Ref.: CVLNC025

CVL Network – Network Code Condition G1 Network Change Proposal:
CVL Transformation programme consultation – Butetown Station Dn Platform 2
Introduction to operational use.

Appendix A1 – Butetown Station Dn Platform 2 Introduction to operational use.

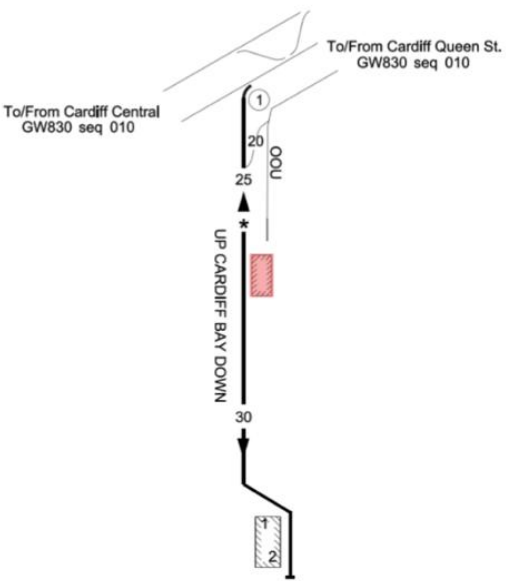
To support the alterations described above, the following revisions will be made to the Western Route Sectional Appendix GW 839 sequence 001.

The new requirements are shown in **Red** font whilst requirements that are to be removed are shown in **Green** font struck through. Explanatory notes are in **Blue** font.

See Annex A1 to Appendix A for detail
